STAFF REPORT

Site Plan Review

Docket No. SP-25-20
Gus' Fried Chicken
Summary No.

Location: 3940 Veterans Memorial Blvd. (Figure 1)

FIGURE 4

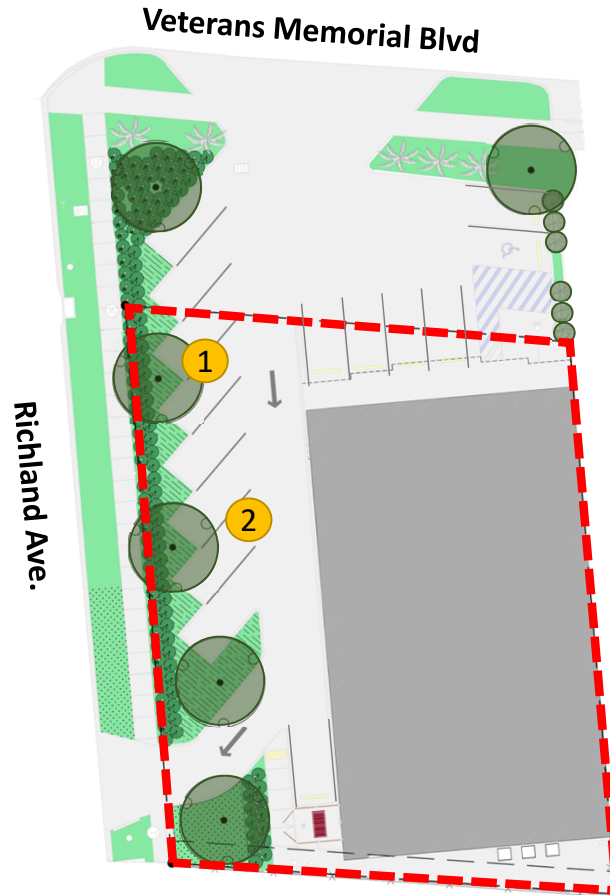
- The request for a variance for 33 parking spaces (84.6%) is a significant deficiency.
- The deficiency of parking on-site may result in spill-over of customer parking onto adjacent property and along Richland Ave.

5. Per Sec. 40-474, the first 20 ft. from the front lot line shall be the minimum front yard and building setback, and shall be landscaped in accordance with section 33-6.25, Landscaping, buffering, and screening. Sec. 33-6.25 states that no parking areas shall be allowed within the 20-ft. front yard. Three new parking spaces are located within the required front yard, necessitating a variance to the CPZ area regulations

6. Per Sec. 40-662, a restaurant requires one parking space for every 150 sq. ft. of gross floor area. The proposed 3,494-sq.-ft. containing Gus’ Fried Chicken would require approximately 23 spaces. The second 2,289-sq.-ft. restaurant unit would require an additional 15 spaces (Table 1). As the site contains six (6) parking spaces within the lot which can be counted towards required parking, a 33-space (84.6%) variance to the parking requirements is necessitated for the current proposal (Figure 4).
